## SERVICE BULLETIN MIIII

126

INSPECTION OF PORT RUDDER BAR FOR CHAFING

T67B, T67C Series, T67M, T67M-MkII, T67M200, T67M260 and T67M260-T3A

FIG 1 CORRECT CABLE ROUTING AND TYING

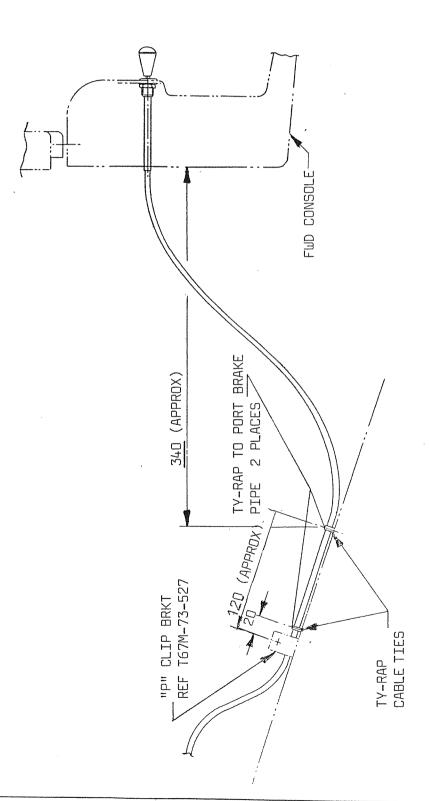
A case has been reported of the hot air control cable fouling and damaging the rudder crossbar due to poor routing.

- 1. Inspect, using a strong light and a mirror, the lower (port) rudder bar above hot air control cable for signs of chafing.
- 2. If no chafing has occurred, ensure cable routing conforms to Fig. 1.
- 3. Should the rudder bar T67M-45-257 be damaged, ie paint removed or grooved to a depth of less that 0.1mm, the rudder bar should be deemed serviceable. repaint damage. A new cable should be fitted according to Fig. 1. Hot air cable Pt No.T67B-74-217 Pre Mod M234, T67B-74-225 Post Mod M234 applicable T67B, T67C Series, T67M, T67M-MkII and T67M200; T67G-74-205 T67M260 and T67M260-T3A aircraft.
- 4. If rudder bar T67M-45-257 is grooved to a greater depth than 0.1mm, strip down rudder bar assembly and return rudder bar to manufacturer for repair, fit replacement rudder bar. Hot air control cable should be replaced and fitted according to Fig. 1.

This SB requires a one time inspection and rectification of the rudder bar and hot air cable routing.
